ADDENDUM # 1

City of Sedalia Project Number: 2024-009

Sedalia Small Sewer Project “A”

Design:	KAL	Drawn:	SBK
SANITARY SEWER PLAN & PROFILE			
Sheet			
C1.01			
ES&S PROJECT NO. 16408

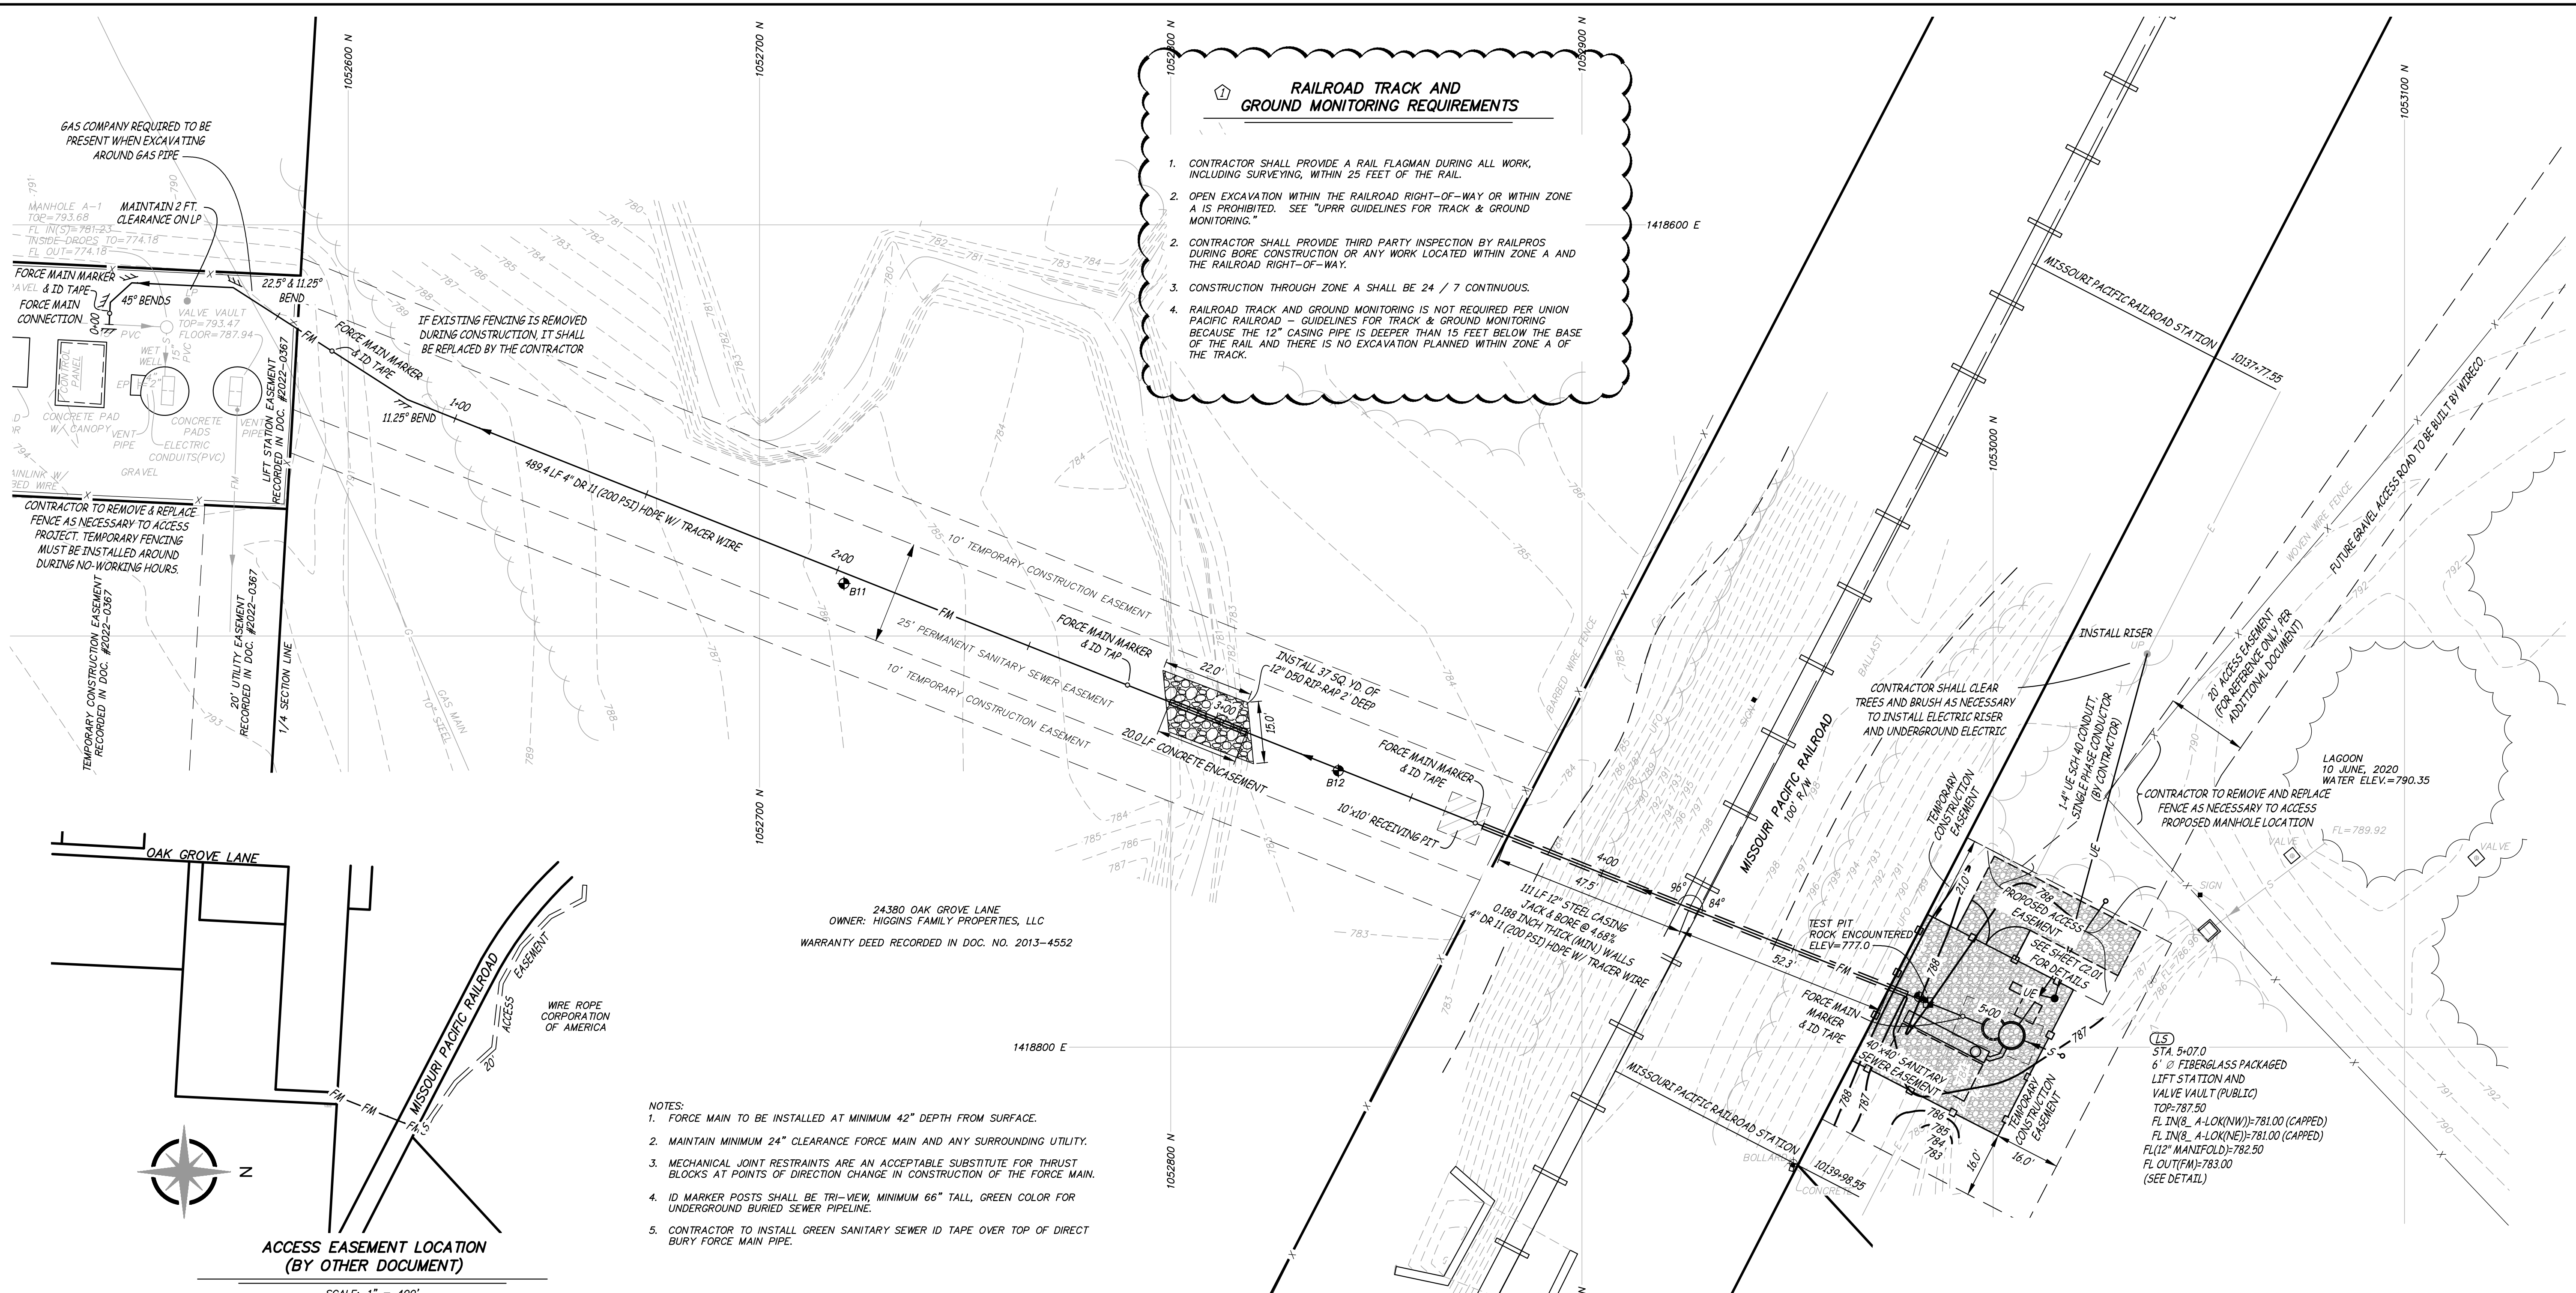
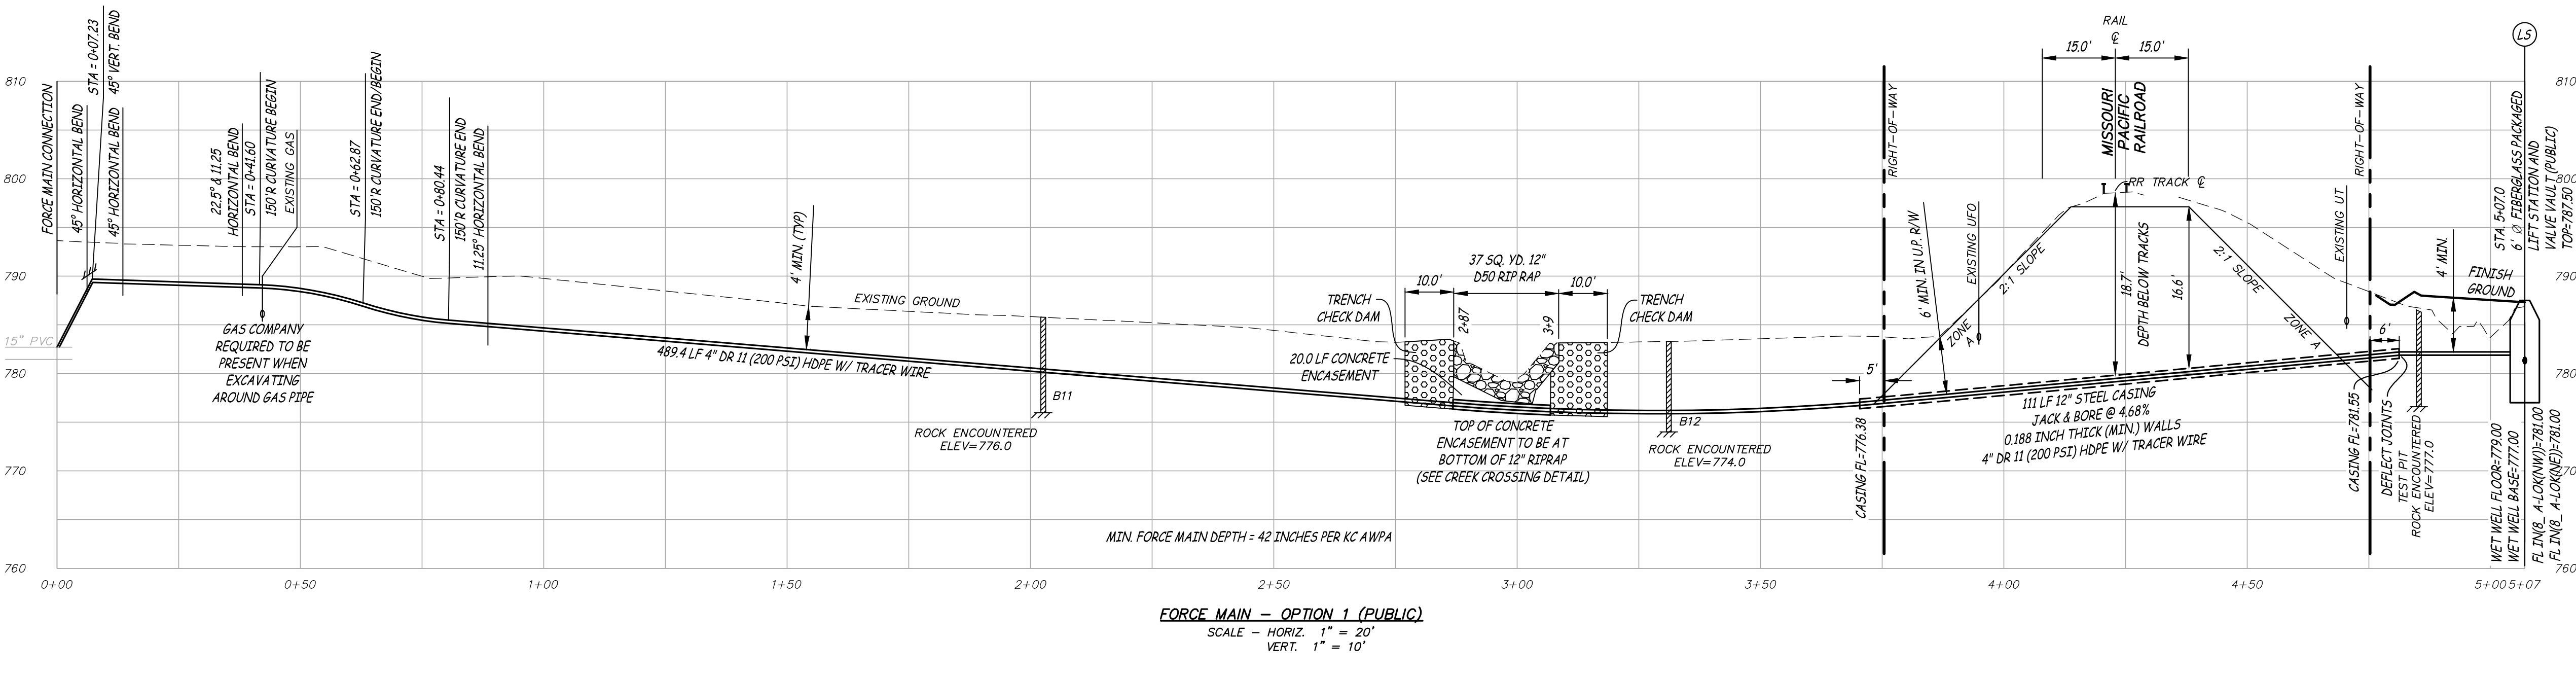
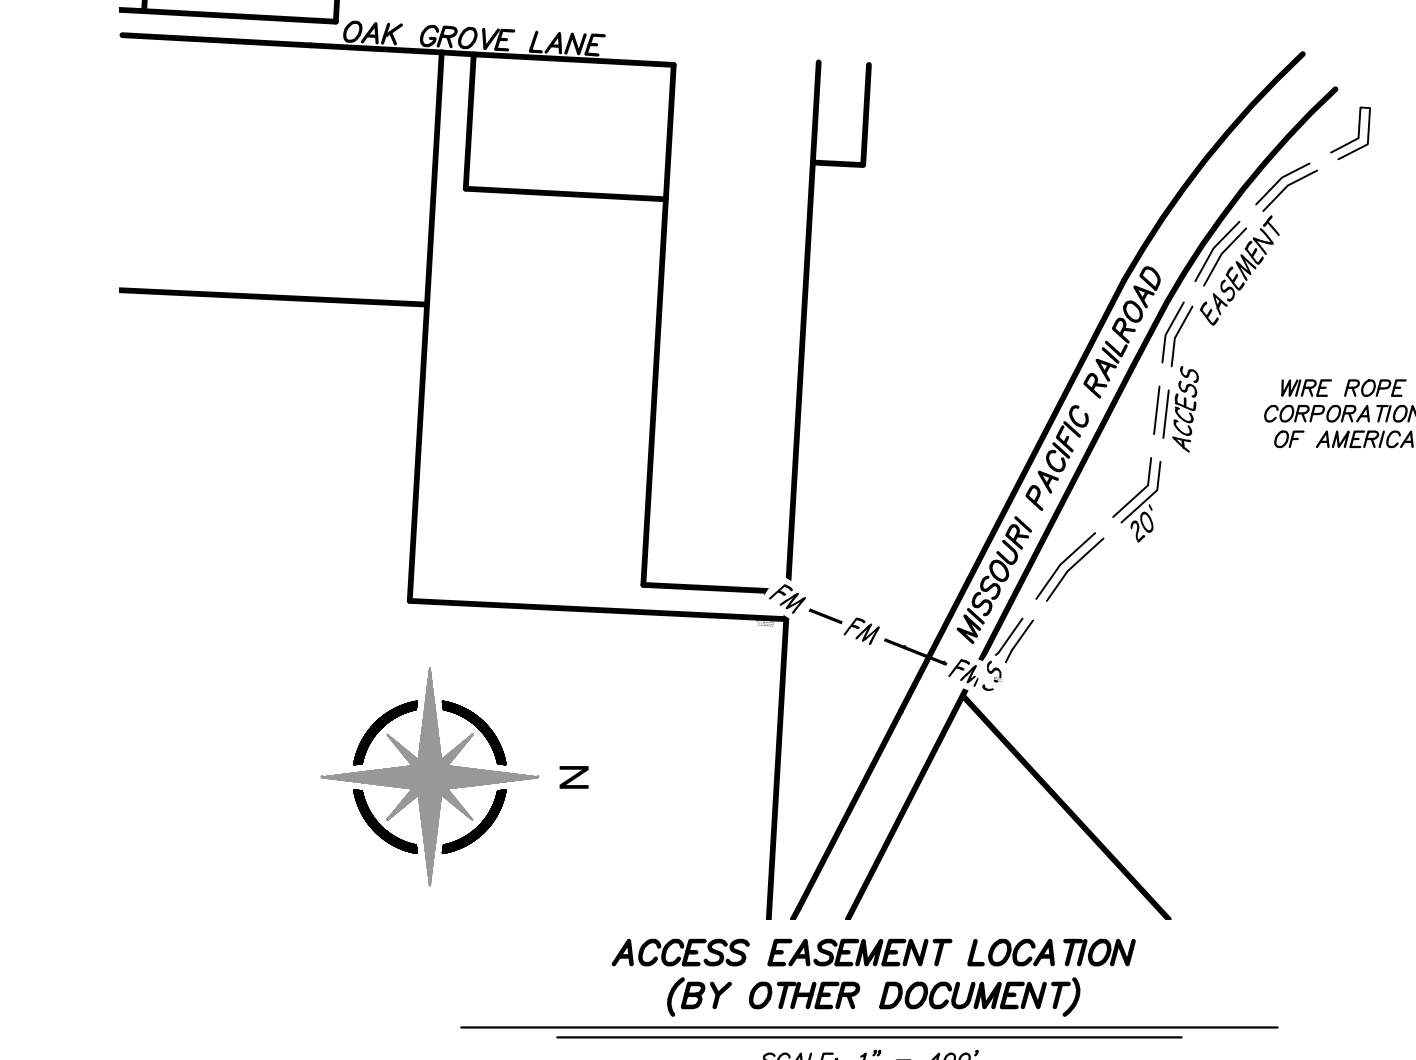
Option #1 Plan Set – sheet C1.01 was revised to add RailPros Construction Observation & Flagging requirements as well as 24/7 continuous construction notes for the bore under Union Pacific Railroad. The revised sheet is included with this Addendum #1.

- CONTRACTOR SHALL PROVIDE A RAIL FLAGMAN DURING ALL WORK, INCLUDING SURVEYING, WITHIN 25 FEET OF THE RAIL.
- OPEN EXCAVATION WITHIN THE RAILROAD RIGHT-OF-WAY OR WITHIN ZONE A IS PROHIBITED. SEE "UPRR GUIDELINES FOR TRACK & GROUND MONITORING."
- CONTRACTOR SHALL PROVIDE THIRD PARTY INSPECTION BY RAILPROS DURING BORE CONSTRUCTION OR ANY WORK LOCATED WITHIN ZONE A AND THE RAILROAD RIGHT-OF-WAY.
- CONSTRUCTION THROUGH ZONE A SHALL BE 24 / 7 CONTINUOUS.
- RAILROAD TRACK AND GROUND MONITORING IS NOT REQUIRED PER UNION PACIFIC RAILROAD - GUIDELINES FOR TRACK & GROUND MONITORING BECAUSE THE 12" CASING PIPE IS DEEPER THAN 15 FEET BELOW THE BASE OF THE RAIL AND THERE IS NO EXCAVATION PLANNED WITHIN ZONE A OF THE TRACK.
